Access Compliance Report Public Rights-of-Way (Curb Ramps)

Main Street: CIELO_ST		Cross Street: ASCENSO_AVE		Location:	SE
ADA ID: RPRK211117132054	Ramp Type: Type 4 - Parallel	Initial Pass/Fail: Fail	Overall Compliance: No	Severity Score:	30
Codes/Mitigation Info/Possible Solution			Field Measurements/Component Compliance

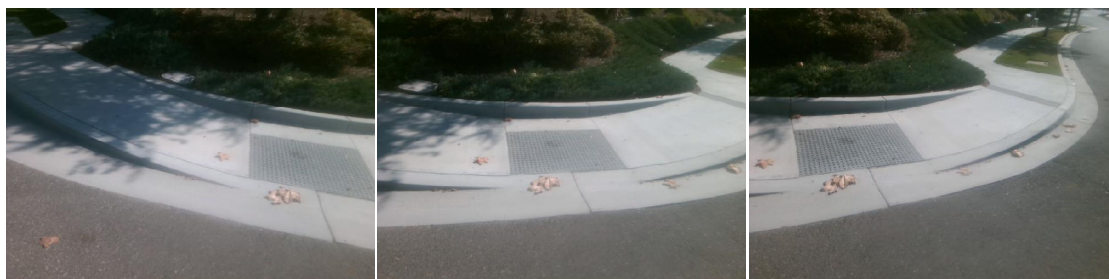
Compliance	Description	Data	Compliance	Description	Data
N/A	Ramp Length LT (in)	112	N/A	Ramp Length RT (in)	115
Yes	Ramp Width LT (in)	53	Yes	Ramp Width RT (in)	53
No	Ramp Run Slope LT (%)	13.1	Yes	Ramp Run Slope RT (%)	3.5
Yes	Ramp Cross Slope LT (%)	0.2	Yes	Ramp Cross Slope RT (%)	0.6
N/A	Landing Present	N/A	N/A	DWS Provided	N/A
N/A	Landing Length (in)	N/A	N/A	DWS Contrast	N/A
N/A	Landing Width (in)	N/A	N/A	DWS Length (in)	N/A
N/A	Landing Run Slope (%)	N/A	N/A	DWS Full Width	N/A
N/A	Landing Cross Slope (%)	N/A		DWS Offset Type	N/A
N/A	Landing Movement Obstructed?	N/A	N/A	DWS Offset Left (in)	N/A
	Landing Movement Type	N/A	N/A	DWS Offset Right (in)	N/A
N/A	Landing Shared	N/A			
N/A	Clear Space	Yes			
N/A	Clear Space To Crosswalk (in)	N/A			
N/A	Marked Crosswalk 1	No	N/A	Marked Crosswalk 2	No
	Crossing 1 Direction	N		Crossing 2 Direction	W
	Marked Crosswalk 1 Width (in)	N/A		Marked Crosswalk 2 Width (in)	N/A

Remove & Replace Curb Ramp With Two New Directional Ramps or Equivalent.

R304.3.2, STD 1115
